SYDNEY OLYMPIC PARK AUTHORITY

Planning Development Application Assessment Report

Application No:	DA 10-09-2019
Application Site:	11 Murray Rose Ave, Sydney Olympic Park, NSW 2127
Proposed development:	Construction of a rooftop amenity space comprising pergola, timber decking and associated landscaping
Applicant:	Charter Hall FLK Funds Management Limited
Determining Agency:	Sydney Olympic Park Authority

Figure 3: Plan of the proposed rooftop amenity terrace

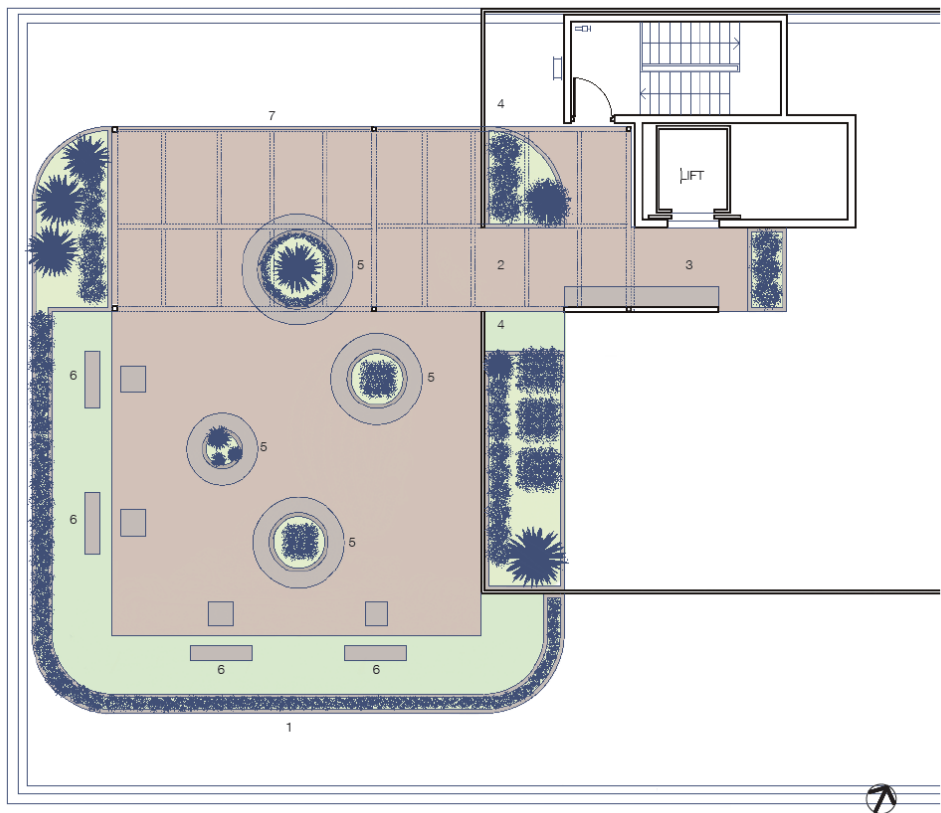
Further, the plans do not indicate the species proposed in the landscaping. However, in order to protect against the potential introduction of invasive species to the Park a condition of consent has been included restricting the inclusion of weed species from the soft landscaping.
